Building Permit Corrections

Project Name: C I T C South Sound Campus - SOUTH BUILDING
Project Address: 402 Valley Ave NW, Puyallup, WA 98371
Project Number: 101 - 104

Site Plan Frontage
A1.10

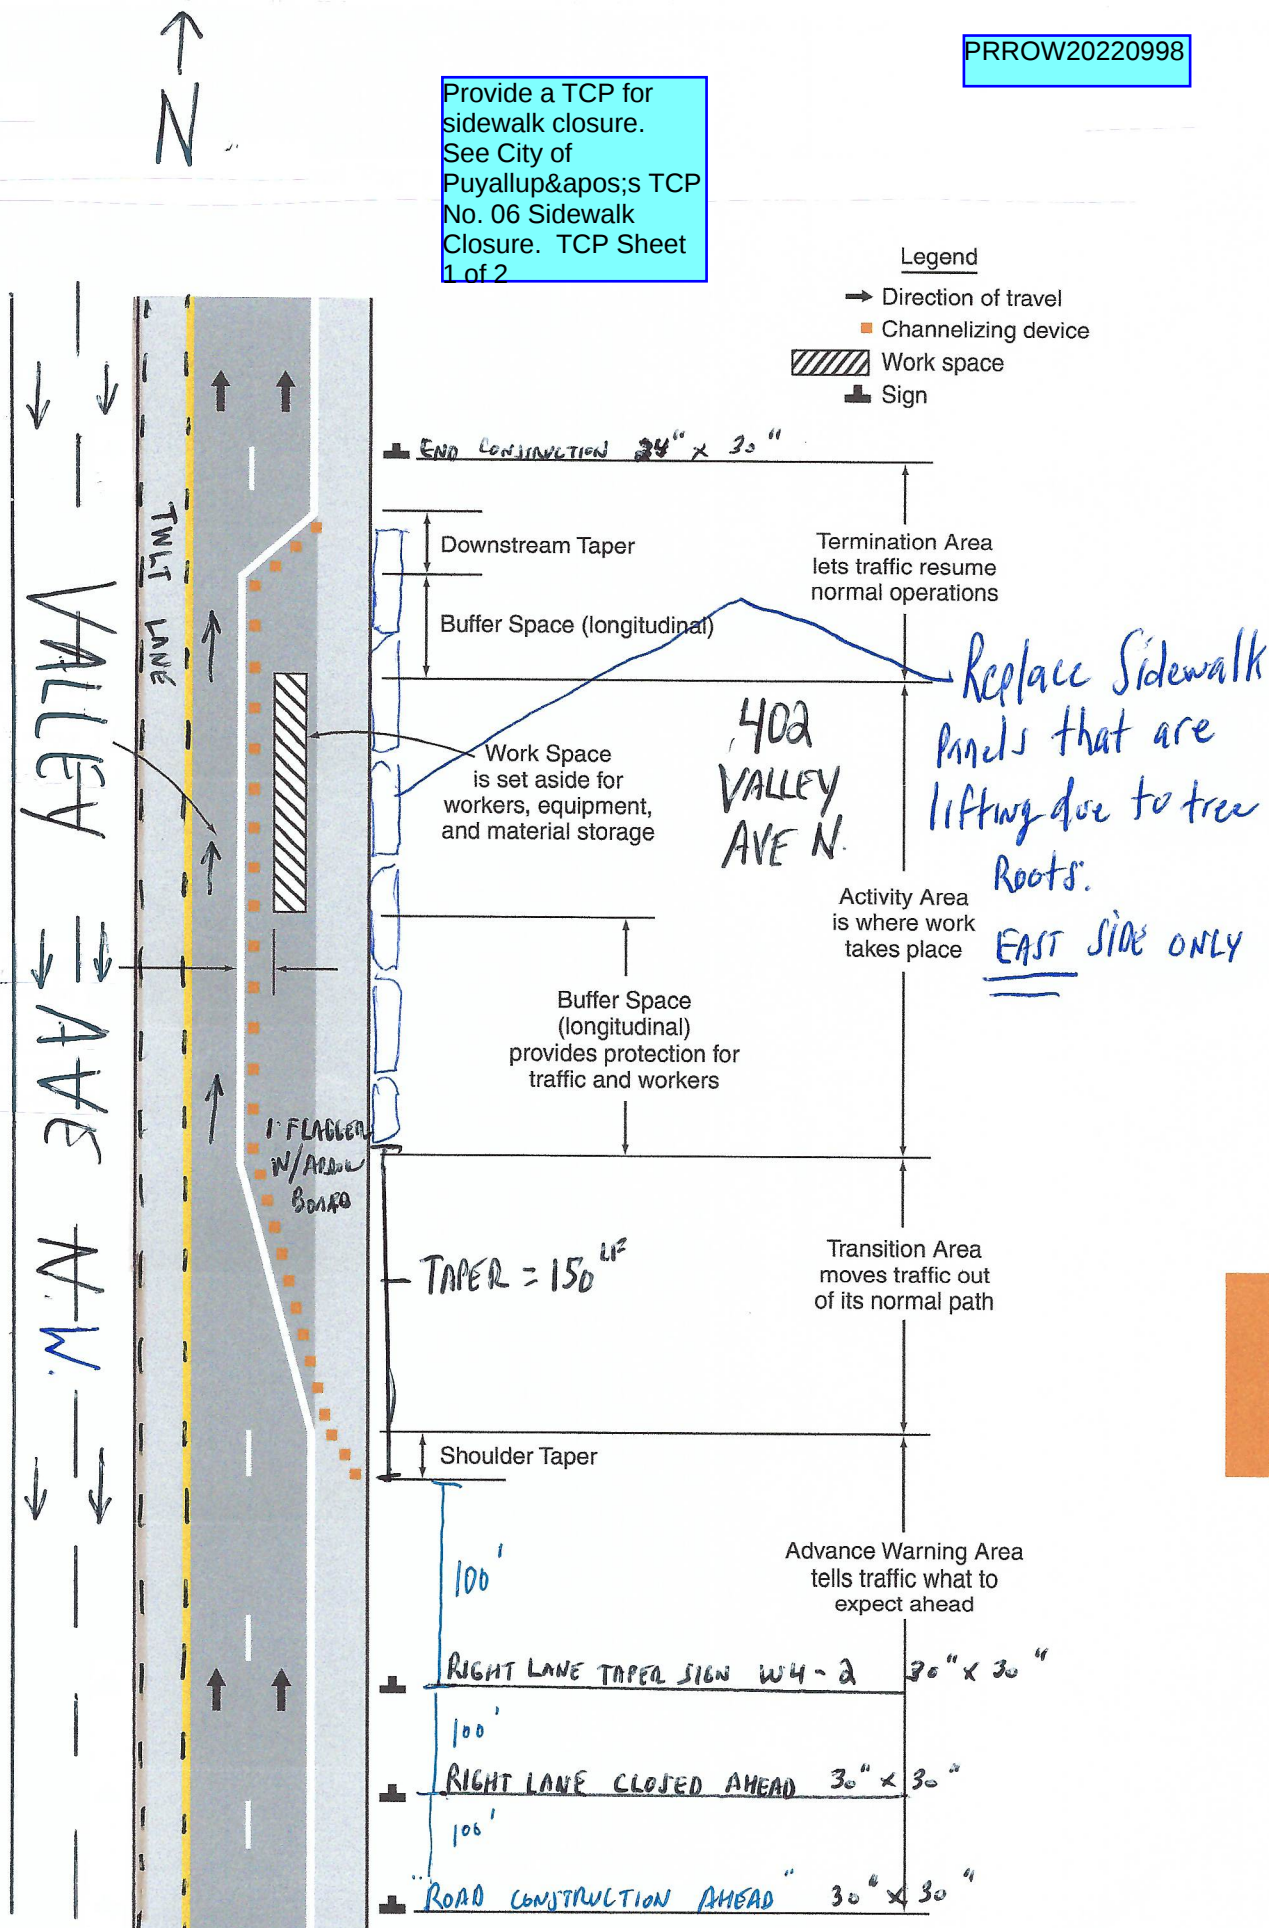
The City offers TCP online on the City's website. These TCPs can be used and or used as a reference for the requirements of a TCP. TCP Sheet 1 of 2

Please explain why a lane closure is necessary for the sidewalk panel replacement. If a lane of Valley Ave NW must be taken the work may be allowed Monday through Thursday 9AM-2PM only. TCP Sheet 1 of 2

Provide a TCP for sidewalk closure. See City of Puyallup's TCP No. 06 Sidewalk Closure. TCP Sheet 1 of 2

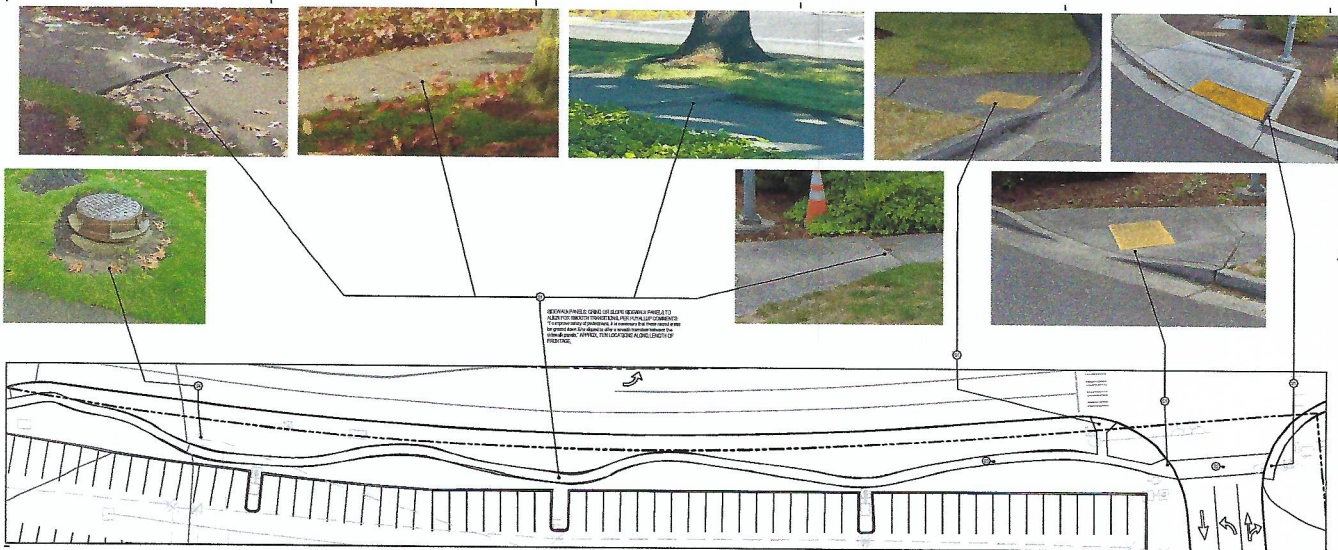
Provide a TCP for the signalized intersection. The TCP must show the correct lane configuration and any detour routes for vehicular traffic that is necessary. TCP sheet 2 of 2
